CHANGE ORDER

Project: Woodland High School Project No.: 1119.00-12
 Architect: McGranahan Architects Change Order No.: 5
 Contractor: Skanska USA Building, Inc. Date: April 14, 2014

Reference	Amount
CCD 006R1 Service Yard Utilities (COR#43)	\$19,237.00
CCD 010 Add Camber to Beams (COR#59)	\$1,083.00
COP 009R1 Power Revisions to Stage Curtain and Operable Partition (COR#41)	\$1,516.00
COP 010 Thickened Edge Slab at the Gym and Aux Gym (COR#37)	(\$1,170.00)
COP 013 Rack and Panel Move at the IDF Room (COR#44)	\$15,077.00
COR 050 RFI#140 - Brace Frame Footing	\$342.00
COR 053 RFI#136 CMU Reinforcement	\$2,244.00
COR 054 RFI #125 Sanitary Sewer Mofications	\$1,480.00
COR 057 RFI#157 Fire Protection Line at Service Yard Door	\$1,283.00
COR 058 RFI#135 Additional Joist Loading North and South Classrooms	\$8,529.00

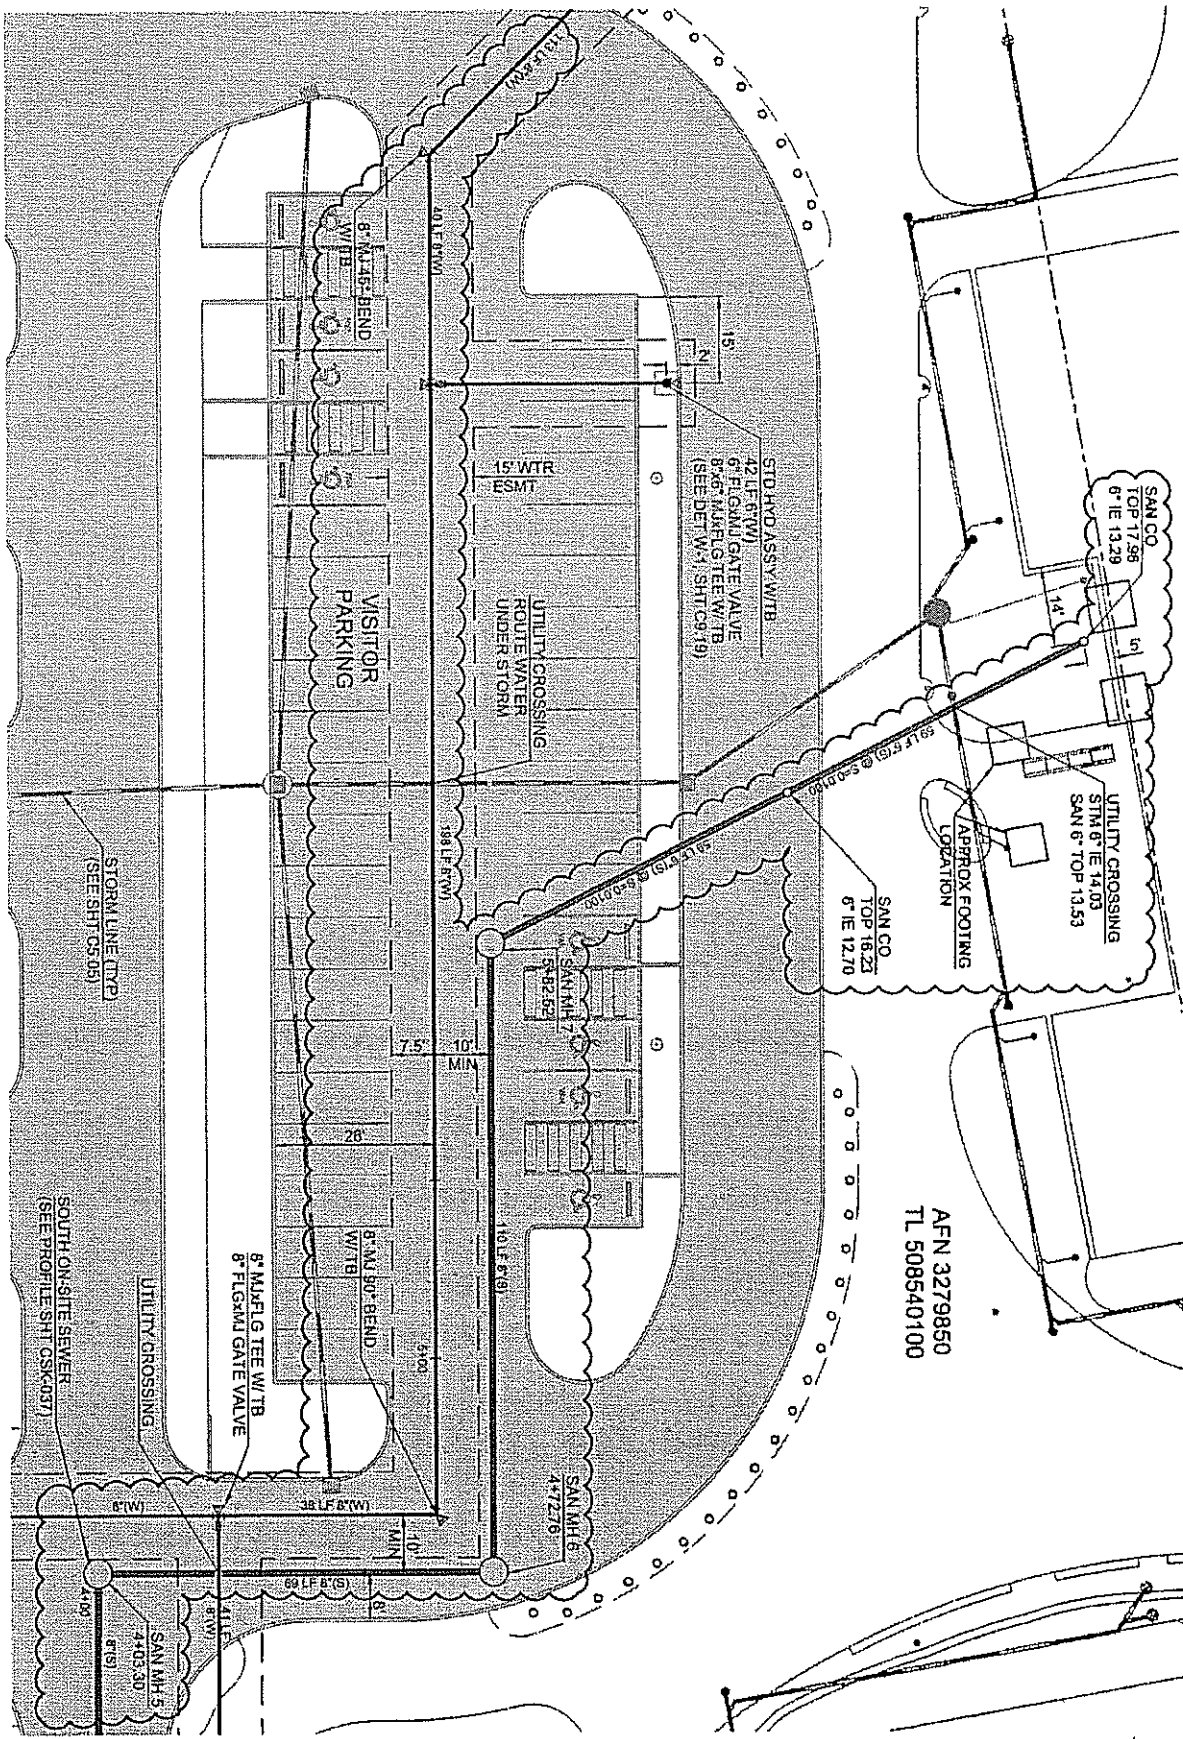
- 1. Per conversations with HDJ (Maureen White) please confirm that the sanitary sewer line at the visitor parking area should be relocated per the attached sketch to avoid (2) utility crossings.
2. It is our understanding that the 4" water line to the grandstands is a private line. Can the sewer/water utility crossings for this line be concrete encased per the attached detail in lieu of the steel casings (see attached sketch identifying 3 utility crossing locations at this line).

- 1. Yes, the sanitary sewer at the visitor parking can be relocated. HDJ will follow up with a sketch showing the new locations for the manholes and inverts.
2. The water line to the grandstands is private; it will be easier for the school to repair/maintain the lines if they are encased in the steel casings. For the two crossings north of the building and near the utility yard, please encase the water line in steel casings as shown in the contract documents. I will consider encasing the line in concrete at the crossing near the gym, please provide information about the credit the school will receive if the line is encased in concrete

See attached sketches CSK-036, CSK-037 and CSK-038. CSK-039 was also added on 3/17/14.

J62 with added point loads

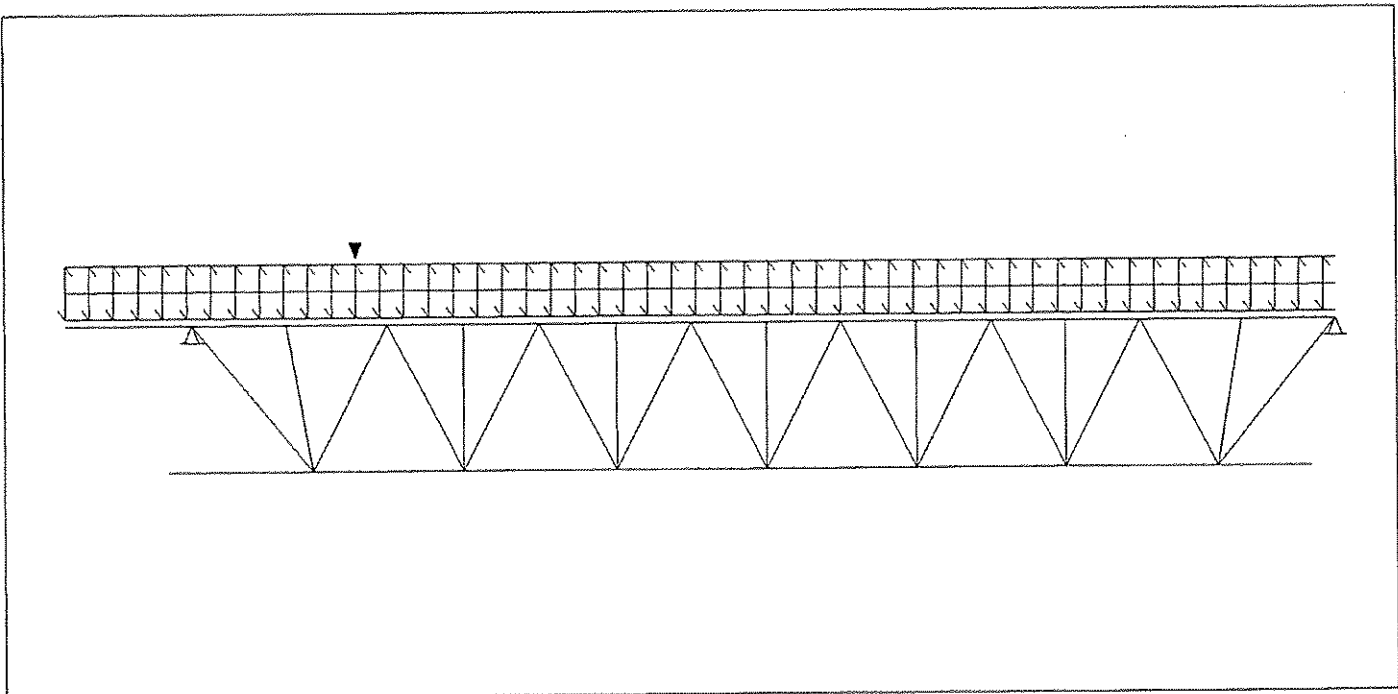
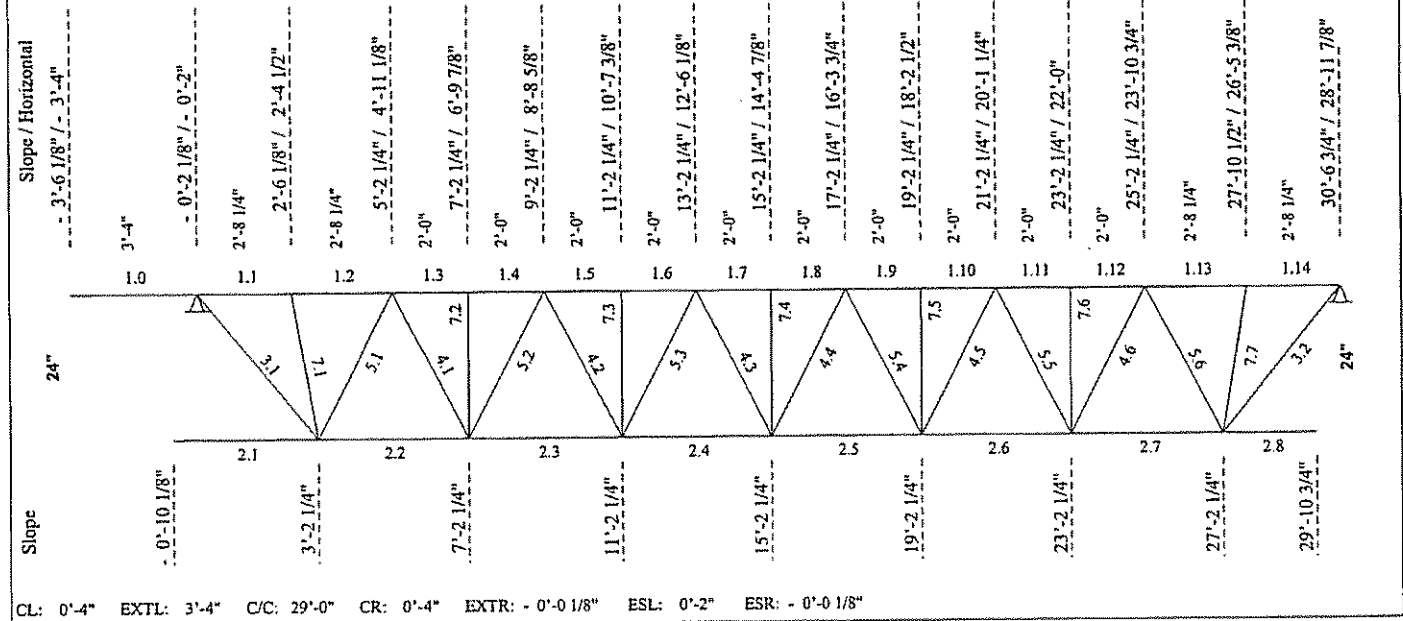
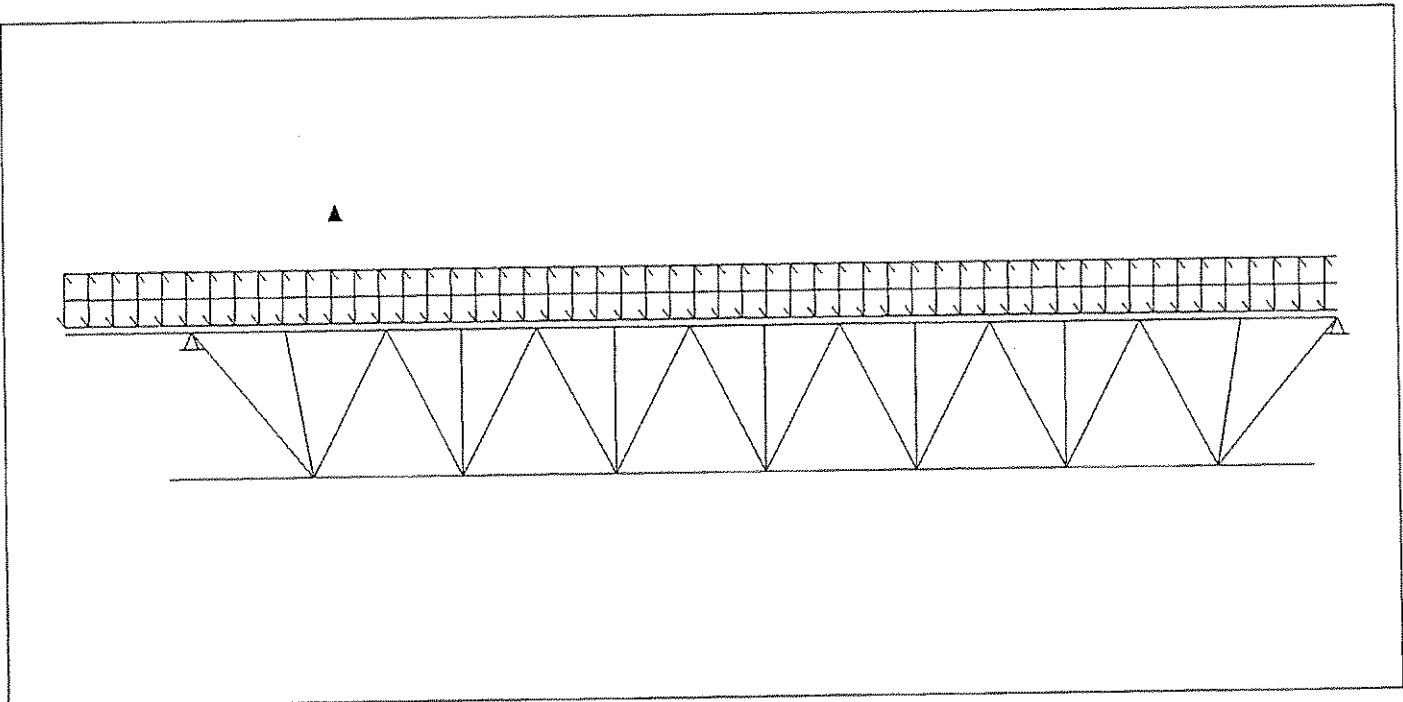
Please see the attached comparison calculation for mark #J62. This mark is a typical mark for the joist with the added 750 point load 4' from grid line.

You will see in the attached calculation that the top chord angle size of the joist is increased when the point load is added.

Weight of joist after point load	346 pounds
Weight of joist before point load	<u>303 pounds</u>
Total difference	43 pounds
affected joist	x 128
Total weight increase	5,504 pounds
or	2.752 tons
This one line item is 81% of the total 3.4 ton increase in weight of NSI Change Order #1

J62 without added point loads

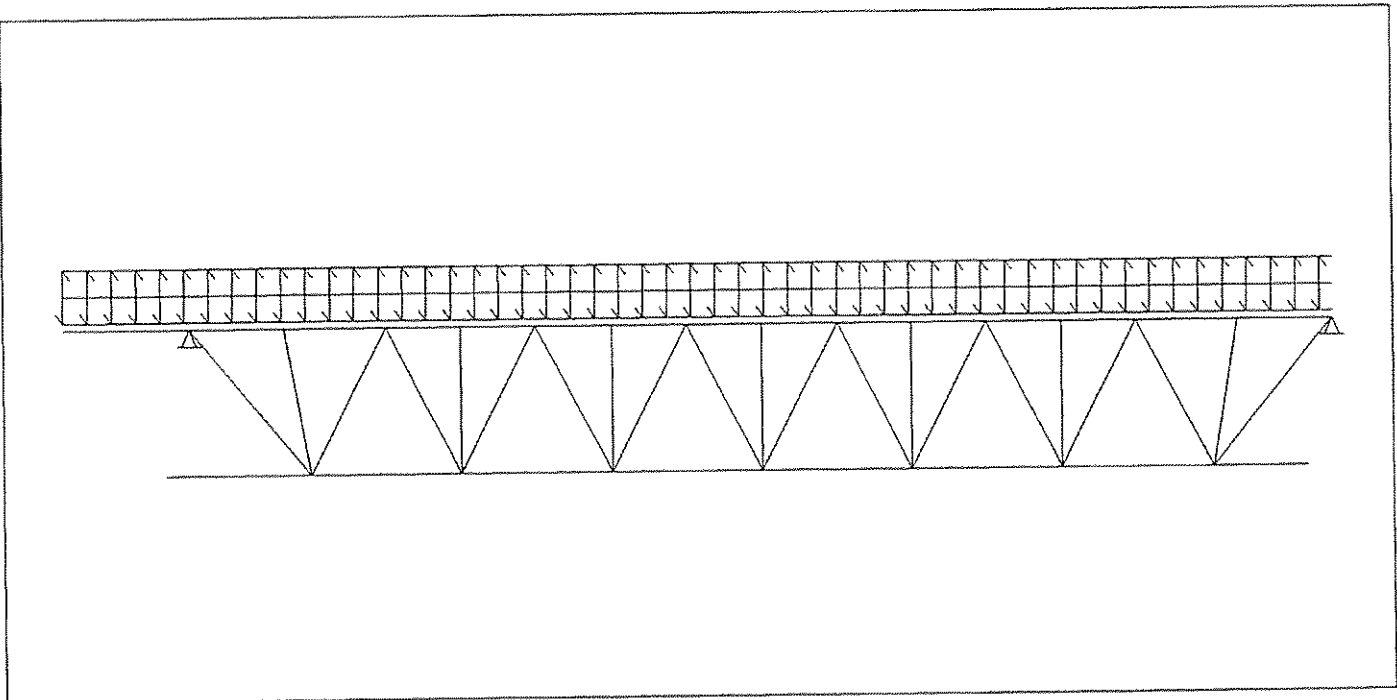
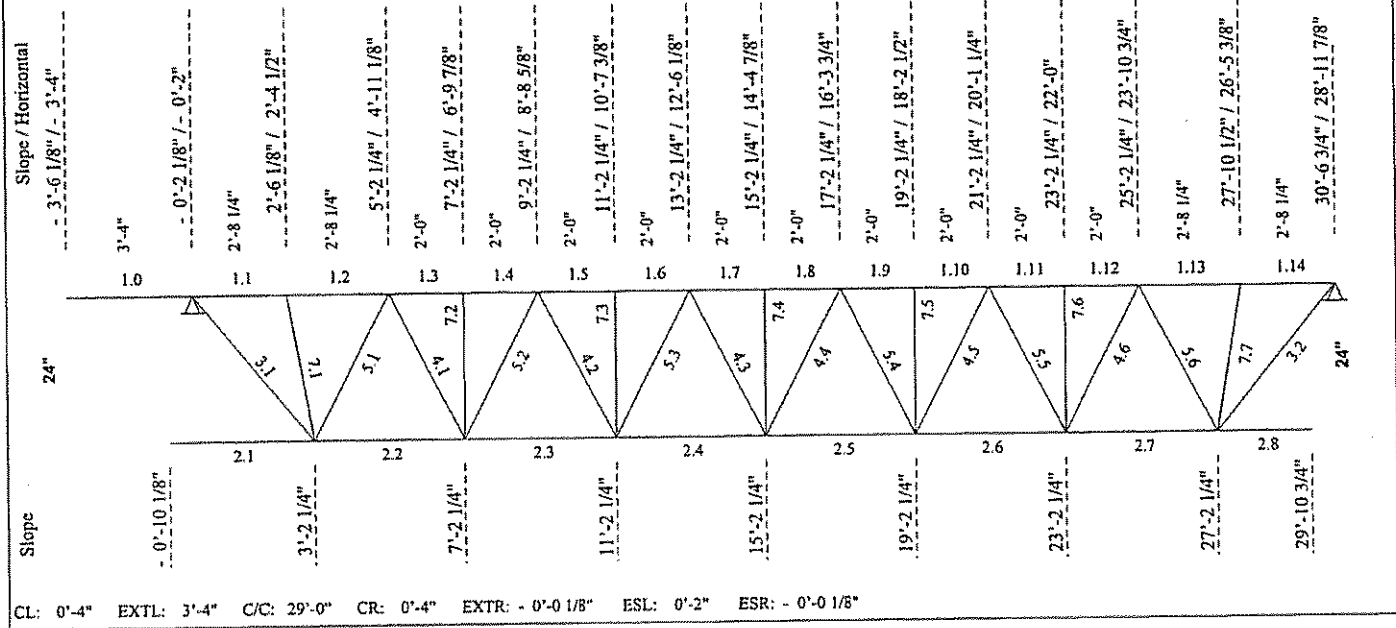
See the next pages for the same mark number ran with out the added point load.
